CITY OF NORTH SALT LAKE

CITY COUNCIL MEETING NOTICE & AGENDA FEBRUARY 18, 2025

Item 10: Discussion of public comment related to the proposed design of Hatch Park – Council direction sought.

Responses from G. Brown Design on Public Comment
2-18-25

A. Sundial

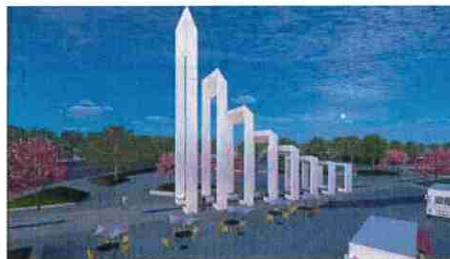
The Sundial is my favorite. If were doing ranked choice, Frames is my #2, Spiral Slats is #3, and the Color Tower is #4. On the Sundial I'd reduce the lettering size of 'Hatch Park' by 10-15%, and add NSL horizontally across the top. This will be, after all, our marquis landing spot for the next few years, so the NSL moniker seems important. I wonder if there could be some automation tied to the lighting elements indicative of impending weather like the Trolley Square water tower? Other thoughts- While I love the look up through the Spiral Slats it's too glitzy for my taste. I was initially drawn to the frames because they doubled as shaded seating opportunities and some great shadows being projects, but the Sundial is my winner for a public park.

A, add climbing ropes to one side

A. It's simple and not gaudy. With the name of the the city or initials, we will show up as a real place. So use the name but not of the park. Very few people would understand what the park is or where what city it is in.
